REMARKS

The present invention relates to a compressor including a compression chamber for compressing working fluid therein, a discharge port through which the working fluid flows out from the compression chamber, and a valve for opening or closing the discharge port. According to one aspect of the present invention, as shown by way of example only in Figure 4, the valve has a valve seat portion 18 provided around the discharge port and having tapered surfaces so that a cross-sectional area of the discharge port increases in a direction away from the compression chamber 21. A valve 17 having a projection portion with a tapered surface is provided so that, in a closed position, at least a portion of the tapered surface is in contact with the tapered surface of the valve seat portion 18. The valve 17 has a flat surface portion provided at an end portion of the valve 17 on the side of the compression chamber 21. A retainer 20 positions the valve 17 on the valve seat portion 18. As set forth in independent claim 5 and as shown by way of example only in Figure 4, a bore 6a is provided in the end plate 6b which blocks an opening of the cylinder 4 (see figure 1). The retainer 20 is inser

FIG. 13

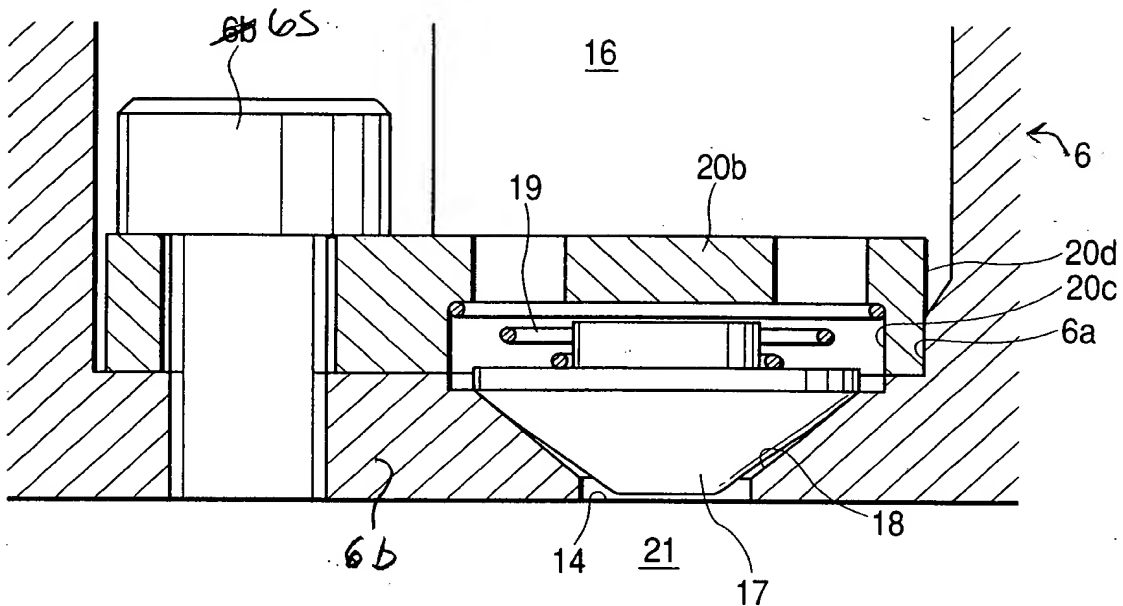
Applicants have amended the drawings to correct the underlining and lead lines and to add reference numeral "6b" to the drawings, as required by the Examiner in the first paragraph on page 3 of the office action.

Approved
m/j
3-25-04
